We thank the reviewer for his/her valuable comments. Here are our responses.

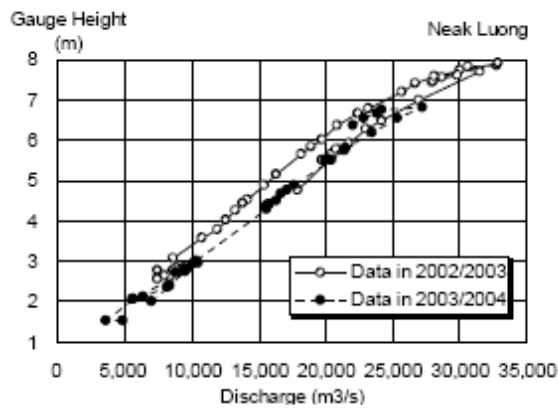
Section 4.1.1, the information and data given in this section can be easily found on the MRC website, so what is the novelty of this section? Additionally, the explanations provided in this section are vague and can be better expressed. For example, lines 174 to 175, where it is “compared to the pre-dam era from 1962-1991,” what is observed from figure 3d and e is that the minimum water level seems not to be higher than the minimum water level for pre-dam era for Neak Luong and Chaktomuk stations, at least it is not tangible. I would like to suggest authors revise this part slightly.

Additionally, no performance index, i.e., R^2 , is provided for Neak Luong’s rating curve to see how reliable this rating curve is. It seems the authors extracted the data presented in Fig. II-3-4 at MRC et al. (2004) to develop these rating curves. Although insignificant, this per se can cause errors.

There is no error in our description. We conducted a Welch’s t-test to compare the minimum water level values and found a statistically significant ($p < 0.05$) increase of +0.10m at Neak Luong. This data is already presented in the supplement. It would be erroneous to judge the significance of change simply by visual analysis of graphs as what the reviewer suggested.

The reviewer assumes that we manipulated data from the graph below:

The allegations are totally untrue and the reviewer should not make such baseless comments.

The R-square value for the said rating curve is 0.979 and is presented in the same section (MRC et al., 2004).
